MIL-R-83536/13
AMENDMENT 2
30 September 1996
SUPERSEDING
AMENDMENT 1
15 December 1995

MILITARY SPECIFICATION SHEET

RELAYS, ELECTROMAGNETIC, ESTABLISHED RELIABILITY, DPDT,
LOW LEVEL TO 10 AMPERES, MAGNETIC LATCH, HERMETICALLY SEALED,
ALL WELDED, TRANSIENT SUPPRESSED DC COIL

This amendment forms a part of MIL-R-83536/13, dated 27 March 1992, and is approved for use by all Departments and Agencies of the Department of Defense.

CIRCUIT DIAGRAM (TRACK MOUNT)
(OPTIONAL INTERNAL
DIODE CONFIGURATION)

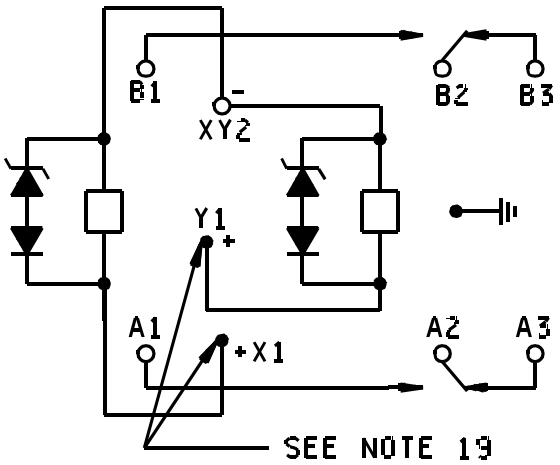
FIGURE 2, add the following circuit diagram:
